TECHNICAL BULLETIN 141112

KEMPER 3" 1502 (STANDARD, NOT HD), 1002, 602 DETACHABLE HAMMER UNION CONNECTION

ISSUE: Kemper's commitment to product improvement has resulted in a revision to the segmented ring sets used for the 3" Detachable Hammer Union connections to further ensure that a proper connection has been made when visually checking for thread exposure.

Figure 1

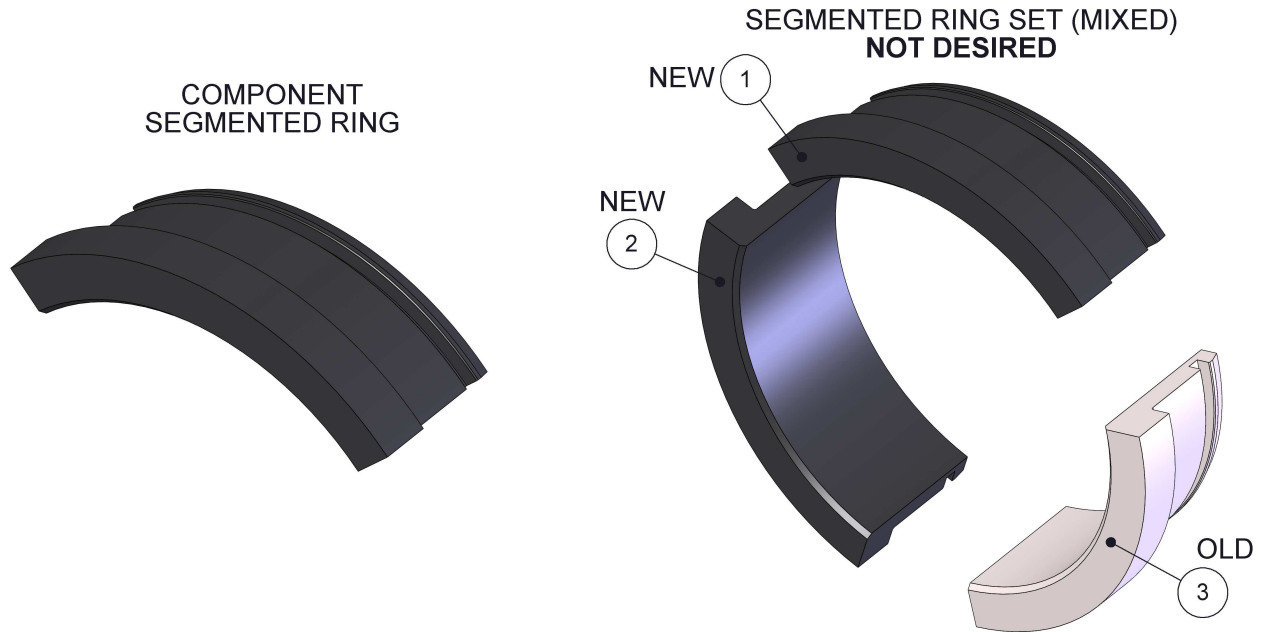
Kemper Valve and Fittings is publicizing the difference between old and new revision segmented ring sets in order to ensure that the component segmented rings of each set are **NOT** interchanged. A segmented ring set consists of three (3) identical component segmented rings – see Figure 1.

The **component** segmented rings must be used exclusively with their respective sets and are not interchangeable between the revisions. **All three (3) of the segmented rings in the set must be of the same revision. DO NOT USE** any combination where only two (2) of the three (3) segmented rings are the same. The new segmented rings differ from the previous revision in that the: overall length is shorter, stop step width is shorter and the **COLOR** is **BLACK** (for identification purposes) vs. the “as-machined” grey steel. It is the overall length and stop differences that make the requirement that all three (3) segmented rings be of the same revision.

Figure 2

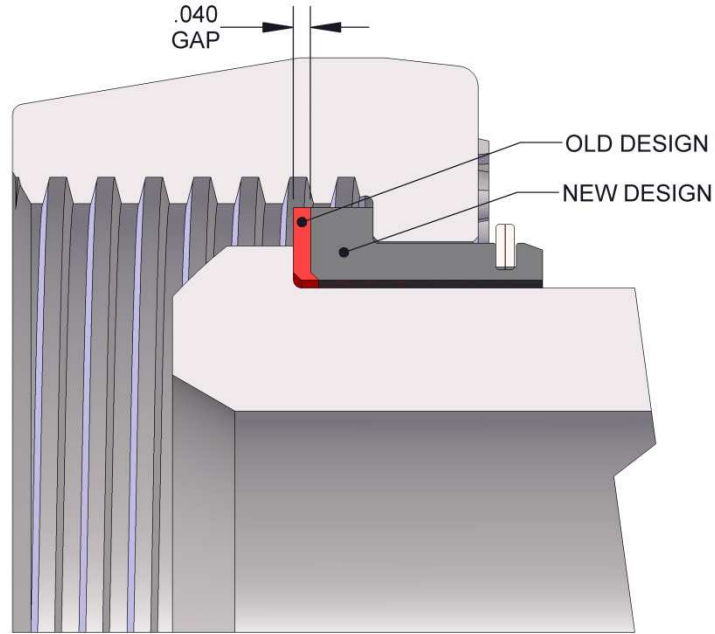
Mixing versions of segmented ring components would cause the nut to bottom out & stop on the old segmented ring (wider) before bottoming out & stopping on the new segmented ring (narrower). This creates a 0.040 air gap & prevents required engagement – see Figure 2.

REQUIRED ENGAGEMENT IS NOT PRESENT

Figure 3

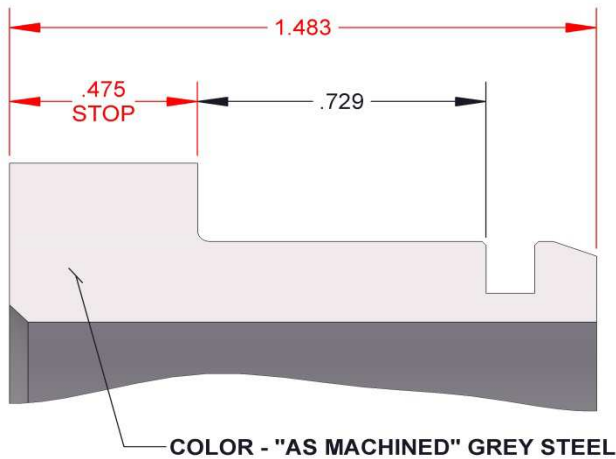
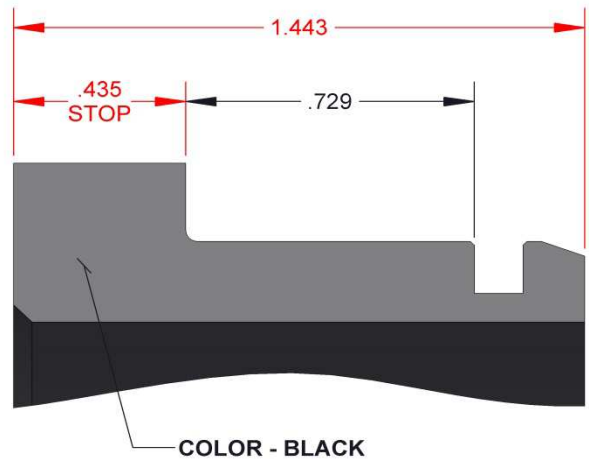
HOW TO IDENTIFY: See Figure 3:

3" FIG 1502/1002/602 END CONNECTION
OLD STYLE SEGMENTED RING

3" FIG 1502/1002/602 END CONNECTION
NEW STYLE SEGMENTED RING

OLD

- 1) Overall **LENGTH** is **1.483** inches
- 2) Stop **WIDTH** is **0.475** inches
- 3) Color is “as-machined” **GREY STEEL**

NEW

- 1) Overall **LENGTH** is **1.443** inches
- 2) Stop **WIDTH** is **0.435** inches
- 3) Color is **BLACK**

ACTION: All products affected are now being supplied with the new revision of the segmented ring sets. If you have these components in-use and/or in-stock, take steps to insure that these two revisions of the segmented rings are **NOT MIXED WITHIN A HAMMER UNION CONNECTION.**
